TO: His Worship Mayor Dan Ruimy
and Members of Council
FROM: Chief Administrative Officer
SUBJECT: Second Reading
Zone Amending Bylaw No. 7826-2022
23682 Dewdney Trunk Road

MEETING DATE: October 17, 2023
FILE NO: 2021-579-RZ
MEETING: CoW

Townhouses
23682 Dewdney Trunk Road, Maple
Ridge

site plan & data

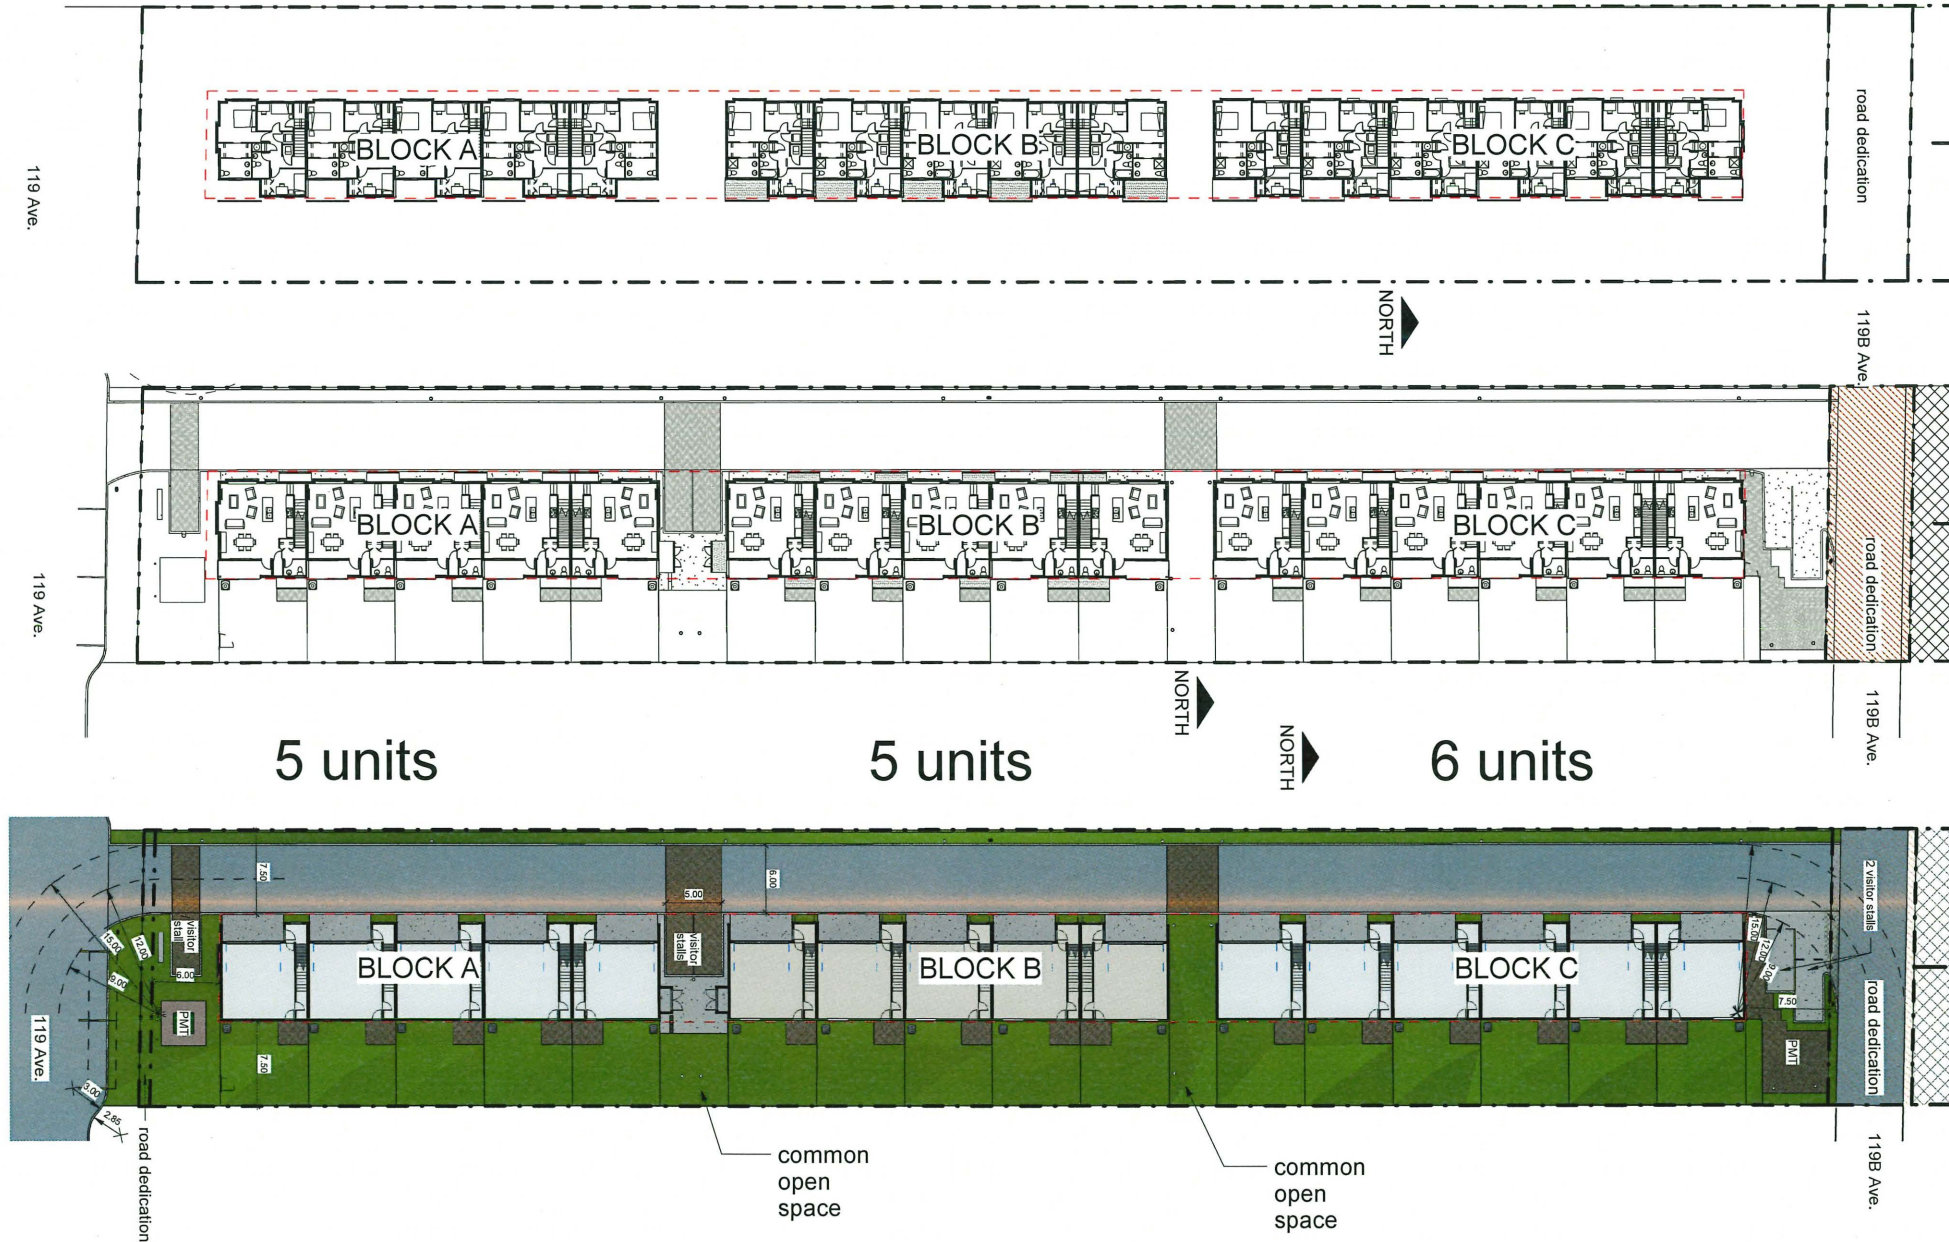
- Consider modern design language for future projects.
- Consider additional colors and material transition/variety at along East elevations.
- The road connecting north and south has canyon effect, please consider adding some bump ins by placing the building blocks in stepping to add bump ins in the road.

- Try to seek variance for rear lot line setbacks to add bump ins on the road side.
- Consider adding more articulation on the rear side to have the same effect as on the road side.

- The road connecting north and south has canyon effect, please consider adding some bump ins by placing the building blocks in stepping to add bump ins in the road. **We understand the issue but, unfortunately, the dimensional and open space requirements make this impossible. The full setback of 7.5m is needed at the rear of the units to provide the amount of Common Open Space required by the zoning bylaw. In addition, we feel that the variance needed to reduce this would not receive Council approval because of serious local community objections. Similarly, on the west side, the face of the units are set close to the setback line and a reduction here would place the garage and unit entries dangerously close to the road. The entries to the units on the west side have been increased in area and now project beyond the main building face permitting the addition of a small roof over the entry.**

- Try to seek variance for rear lot line setbacks to add bump ins on the road side. **See above**
- Consider adding more articulation on the rear side to have the same effect as on the road side. **The east elevation is already articulated with highlighted colours in the recessed portions and block B now has an additional colour scheme**

material & colour palette

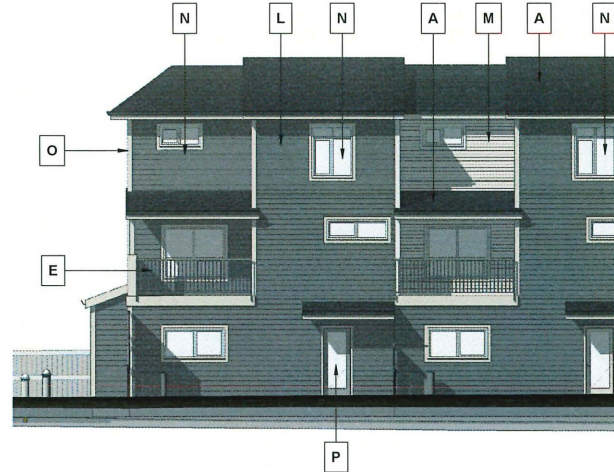
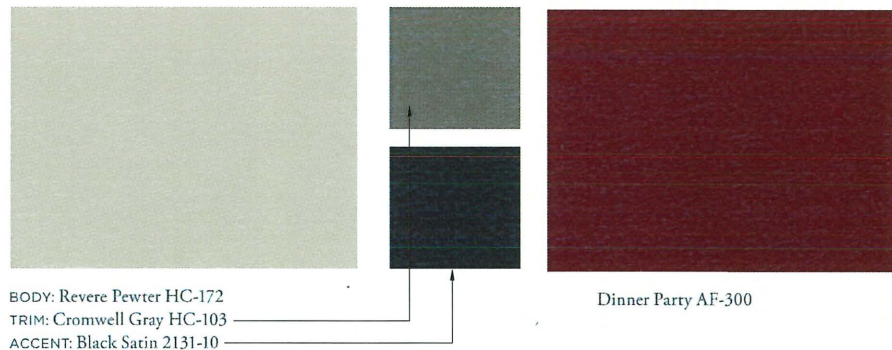
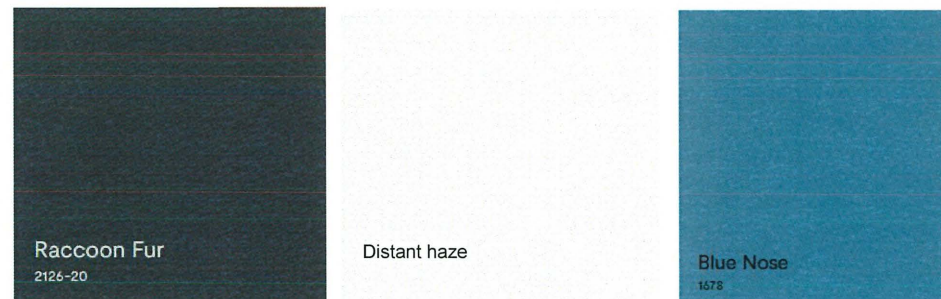
- Suggest providing architectural interest and variety to east façade of buildings using different accent colours and materials.
- Suggest revisiting the composition of the blocks' end facades, north and south, in order to introduce architectural features that would provide additional visual interest (i.e. windows, balconies, overhangs, feature materials, etc...)

- Introduce additional accent colours on top of the proposed red so that each block is accentuated with a different colour.
- Suggest relocating the PMT to north end of the site, it is currently competing with the site sign beside the main site access.
- Suggest revisiting the bio-swale design along the east edge of the site. It seems unrealistic to implement a continuous functioning bioswale across all private patios. Ensure proposed drainage does not discharge off-site or create ponding areas.
- Suggest widening the outdoor amenity spaces for usability, perhaps reduce planting to achieve a more square space and introduce a table or two for informal picnics. Suggest one arbor per space.
- Suggest introducing street lights or bollard lights along the west verge to achieve adequate street light levels (CPTED) and to make it more pedestrian friendly.

LANDSCAPE PLAN
16 UNIT
TOWNHOUSE DEVELOPMENT
23682 DEWNEY TRUNK ROAD
MAPLE RIDGE, B.C.

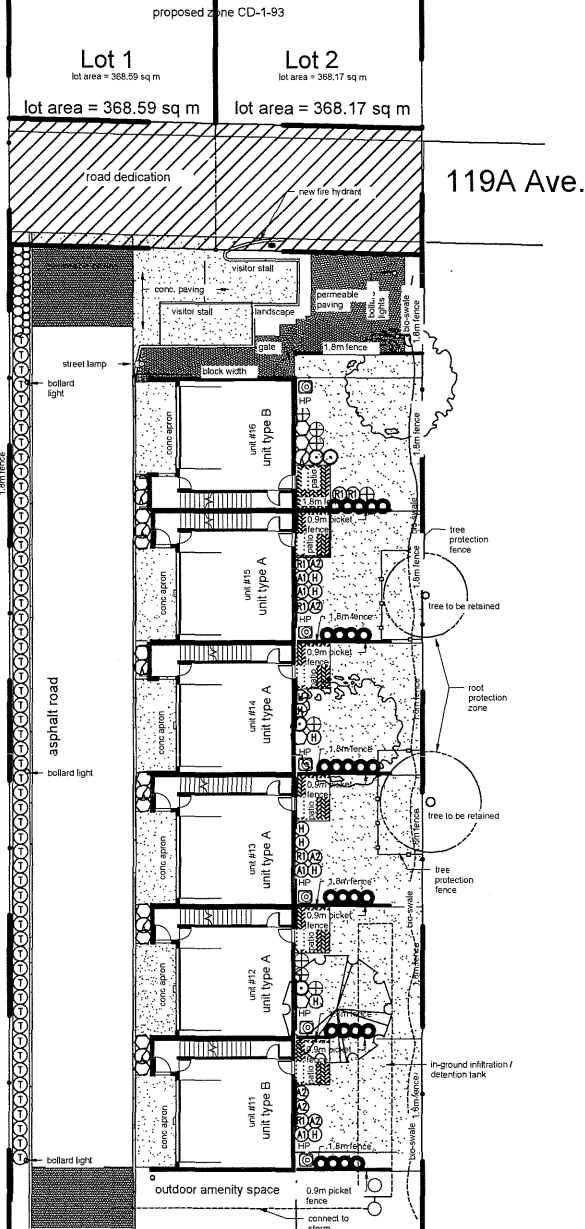
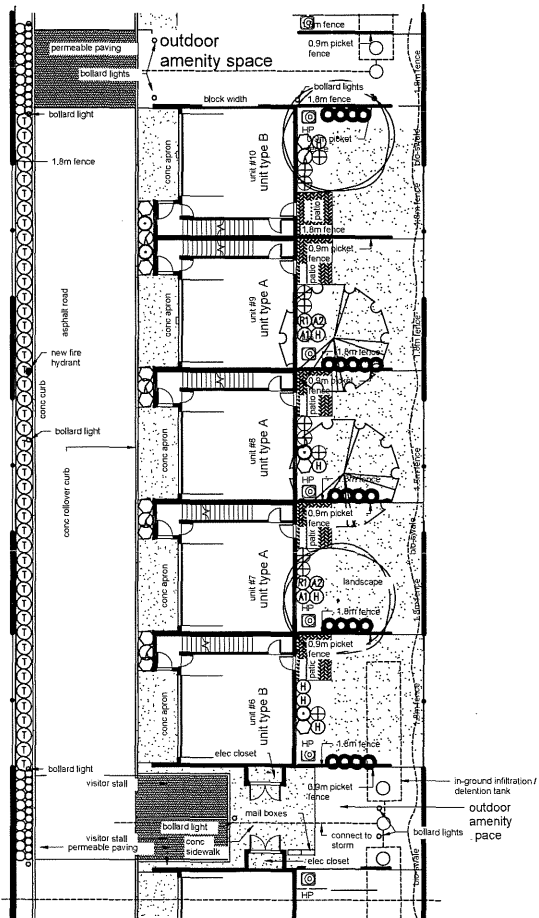
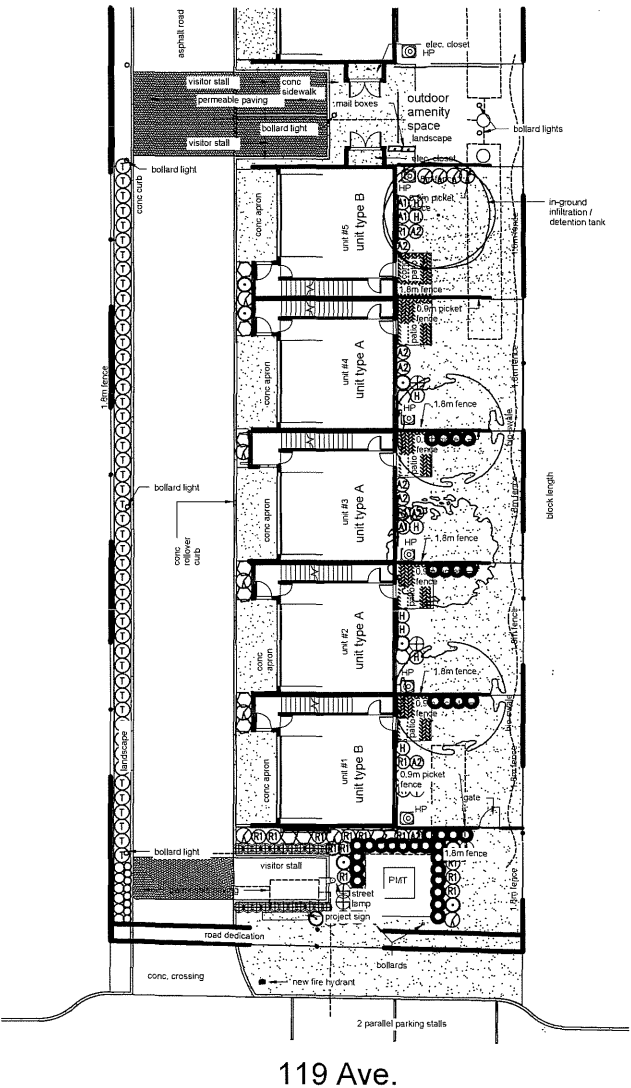
- The landscape design is relatively simple given the long narrow site.
- Presentation of landscape drawings online was low resolution and drawings of amenity areas were quite small. Provide colour landscape plans in future with larger scale drawings of amenity areas.
- Suggest relocating mail boxes between Blocks A and B to improve access and usability of the amenity space
- Suggest introducing additional landscape and architectural features that would contribute to reducing the visual linearity of the lane, for example:
 - Introduce different paving materials like permeable pavers areas at the beginning and end of the lane and in front of the common open spaces.
 - Introduce different hedge species, perhaps aligned with the suggested pavers areas above.

- The landscape design is relatively simple given the long narrow site. Agreed
- Presentation of landscape drawings online was low resolution and drawings of amenity areas were quite small. Provide colour landscape plans in future with larger scale drawings of amenity areas. Coloured landscape site drawings have been added to the drawing package.
